Change Order

PROJECT (Name and address): Rapid City Utility Maintenance Facility Rapid City, South Dakota	CHANGE ORDER NUMBER: 001 DATE: November 25, 2014	OWNER: <input checked="" type="checkbox"/> ARCHITECT: <input checked="" type="checkbox"/> CONTRACTOR: <input checked="" type="checkbox"/> FIELD: <input type="checkbox"/> OTHER: <input type="checkbox"/>
TO CONTRACTOR (Name and address): SECO Construction, Inc. P.O. Box 2921 Rapid City, SD	ARCHITECT'S PROJECT NUMBER: 13373 CONTRACT DATE: September 17, 2014 CONTRACT FOR: General Construction

Work Changes Proposal Request

RFP #: 1	CITY OF RAPID CITY UTILITY MAINTENANCE FACILITY	13373	A1
REVISED ENLARGED PLAN - C5/A-401			
Scale: 1/4" = 1'-0"	DATE: 09/26/14

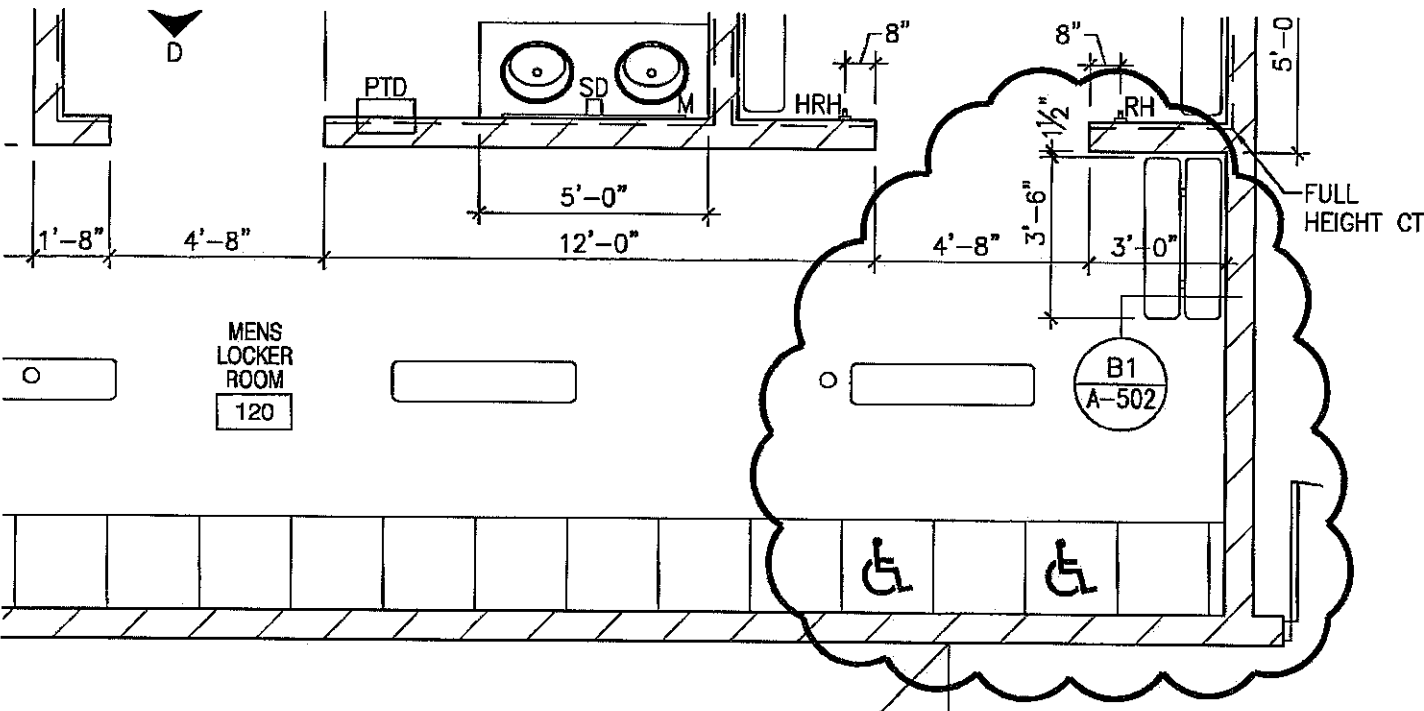
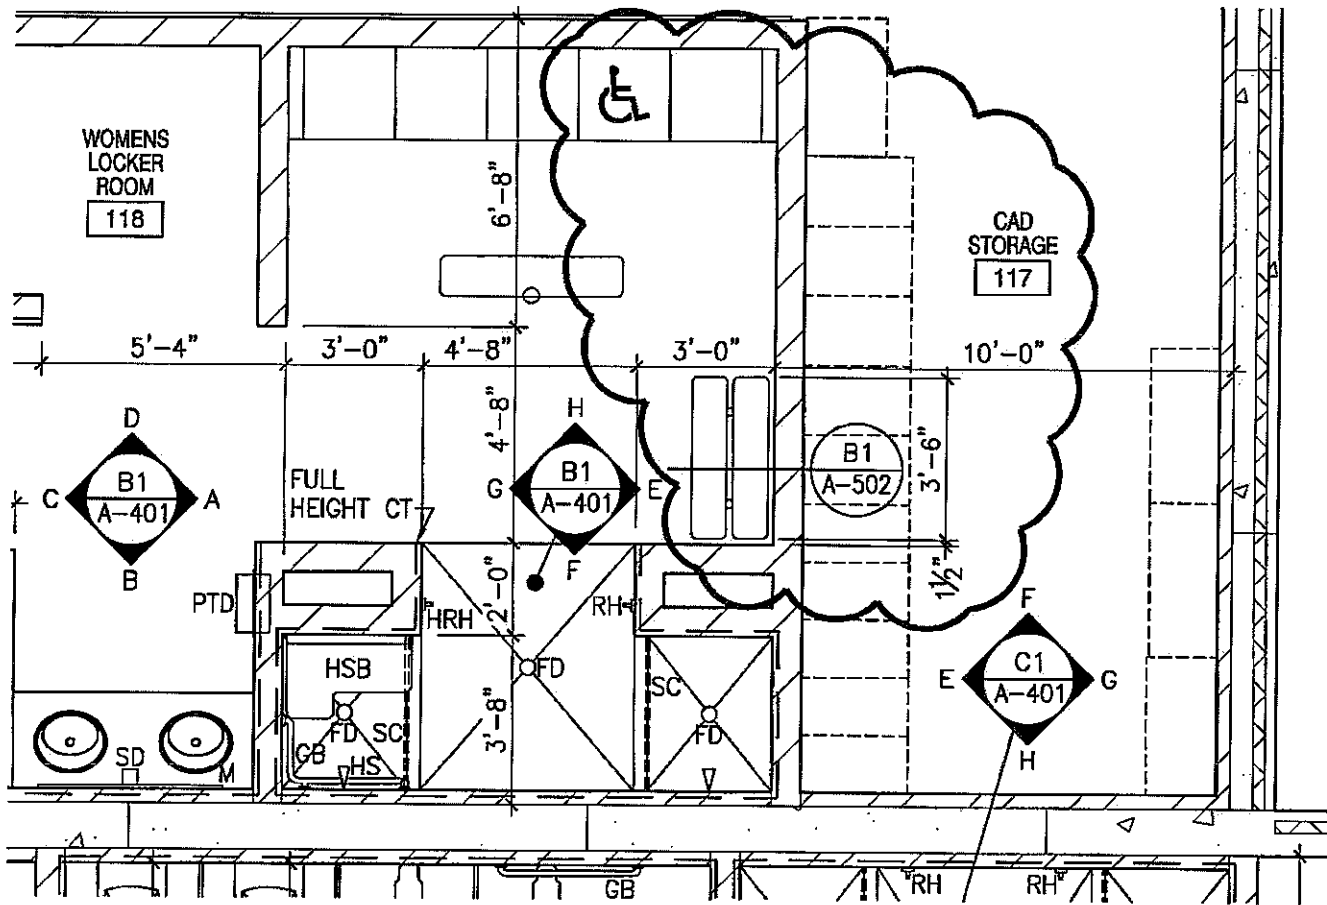
1. Provide and install two (2) 20" x 42" ADA benches as shown and detailed on attached Drawings A1 and A2.
2. Provide three (3) ADA compliant lockers in Men's and Women's Locker Room where shown per attached Drawing A1.
3. Provide an exit sign mounted on the walls (at columns 1 and 3.1) at the top of each mezzanine stair (arrow pointed down stairs) in compliance with IBC. Externally illuminate to 5 f-c by the adjacent fixture F3. Measure and confirm fixture type F3 provides at least 5 f-c on the face of the sign.

Example of Excavation Section Showing Various Surveyed Surfaces

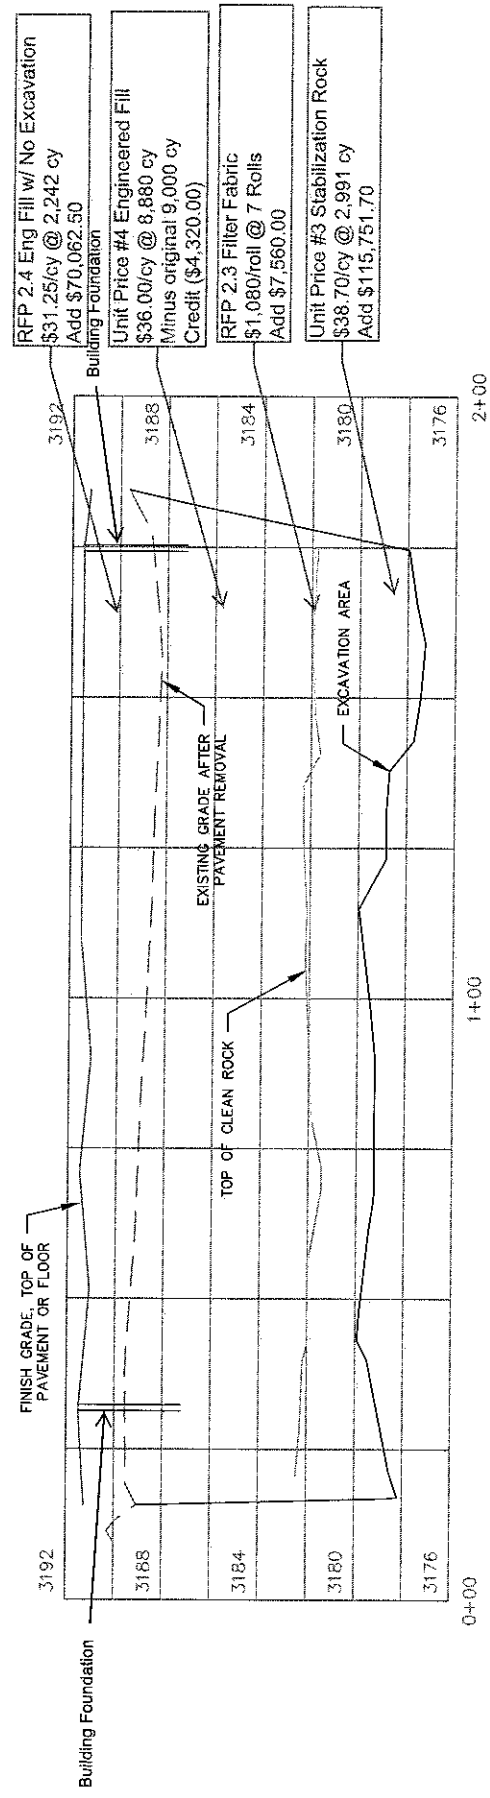
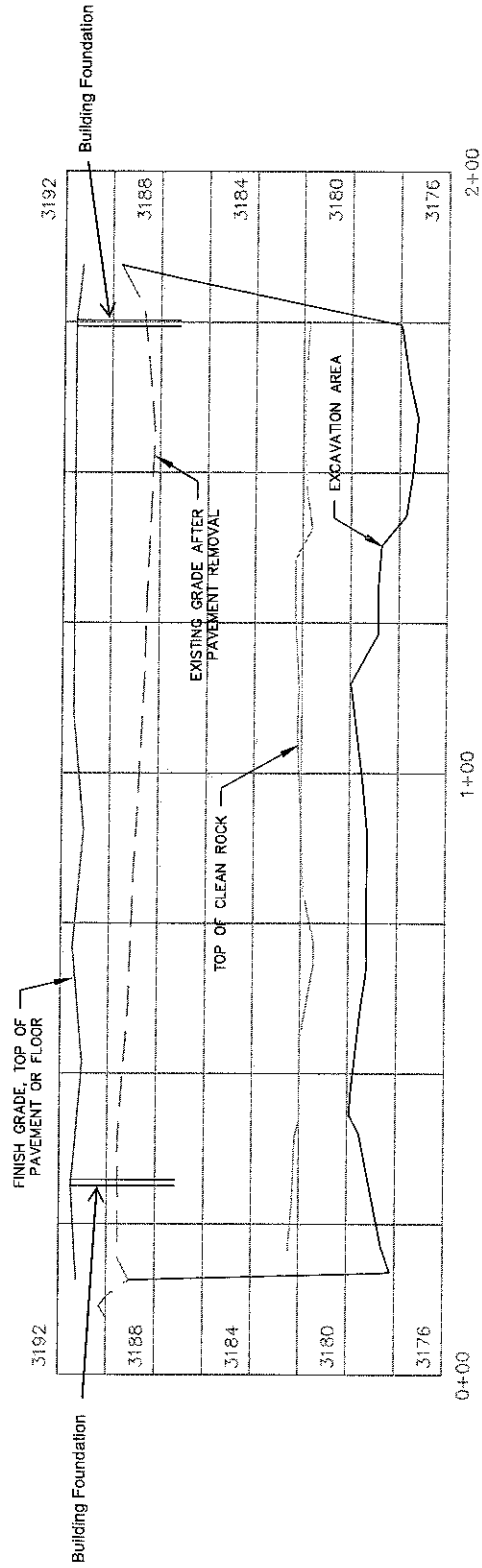
Based on the 9000 CY in the Contract, there should be a deduct of 120 CY of engineered fill @ \$36.00 = \$4320

The stabilization rock should be 2991 @ \$38.70 = \$115,751.70.

RFP #: 4	CITY OF RAPID CITY UTILITY MAINTENANCE FACILITY	13373	A1
REVISED WALL SECTION - A4/A-302			
Scale: 1/2" = 1'-0"	DATE: 11/04/14

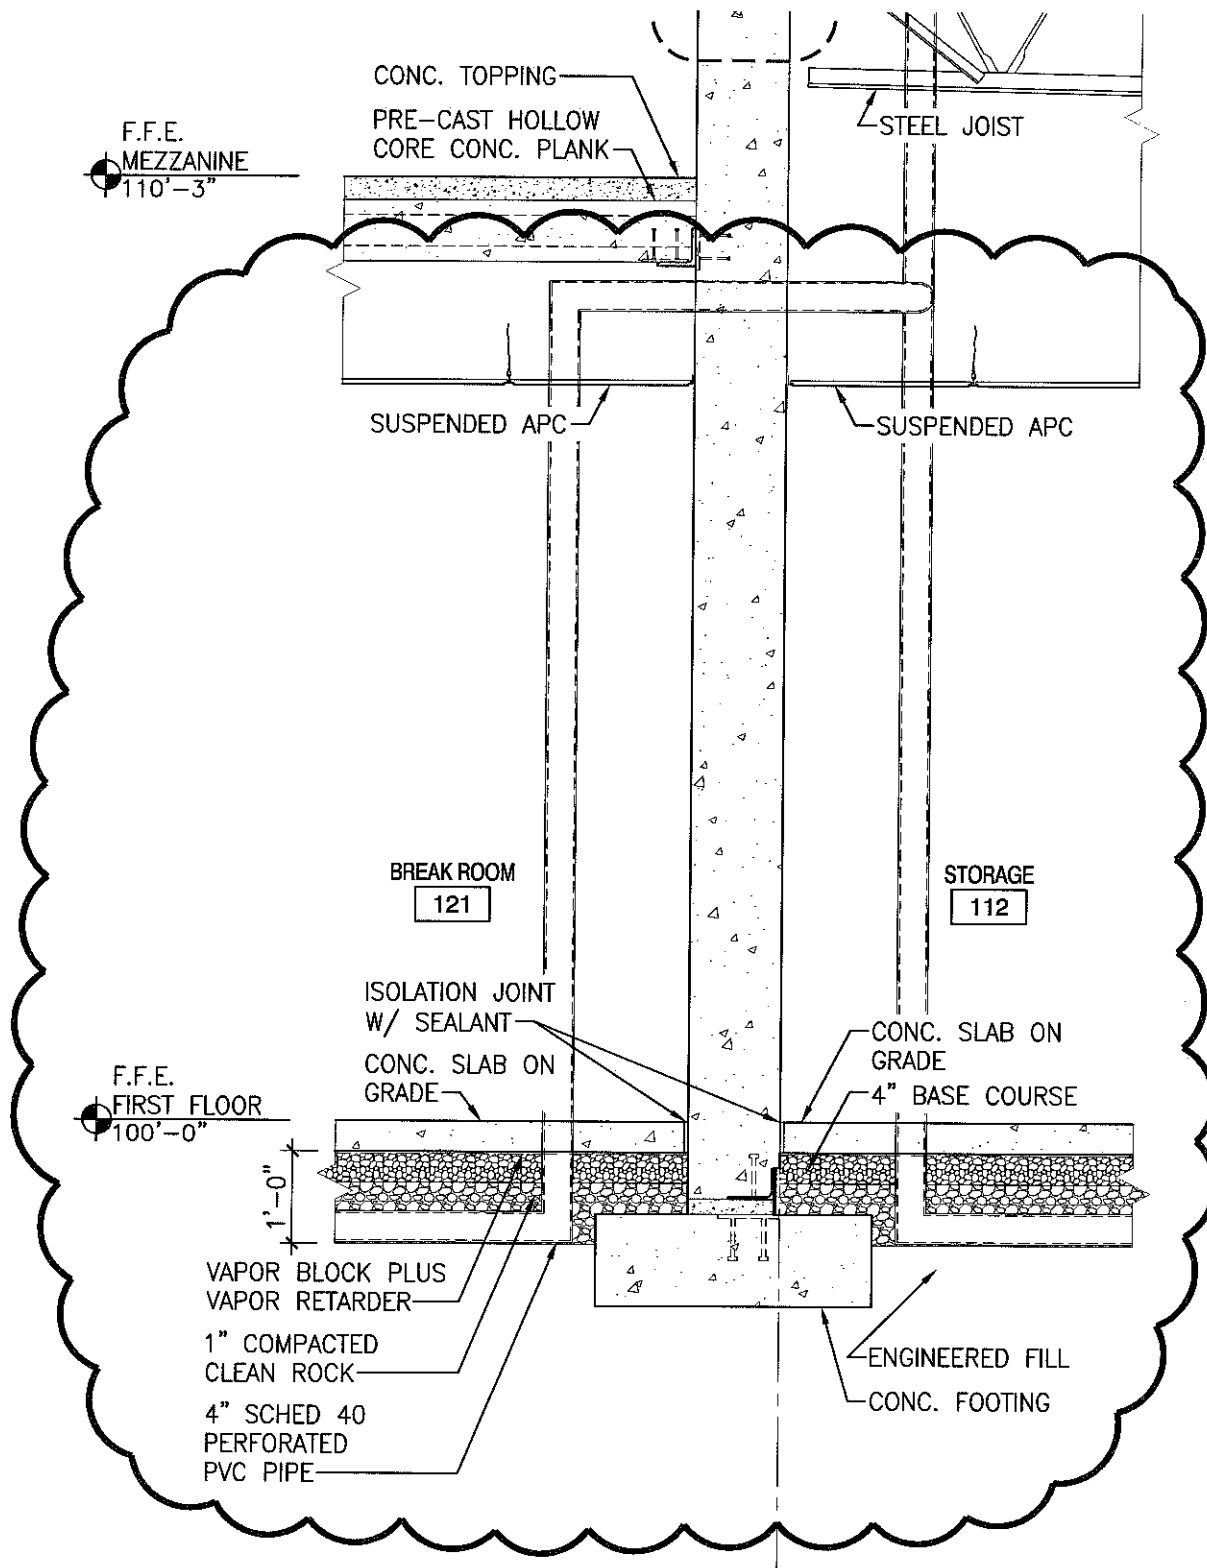
1. Provide 4" Schedule 40 perforated PVC piping below slab and solid wall PVC vent up thru roof as shown on attached sketches MSK4-1, MSK4-2, MSK4-3, MSK4-4. Install 1" clean rock to a depth of 8". Provide and install Vapor Block Plus in lieu of Vapor Block VB6-VB10 previously approved. Modification is required to alleviate possible VOC migration due to contaminated soils in the area of occupied spaces.
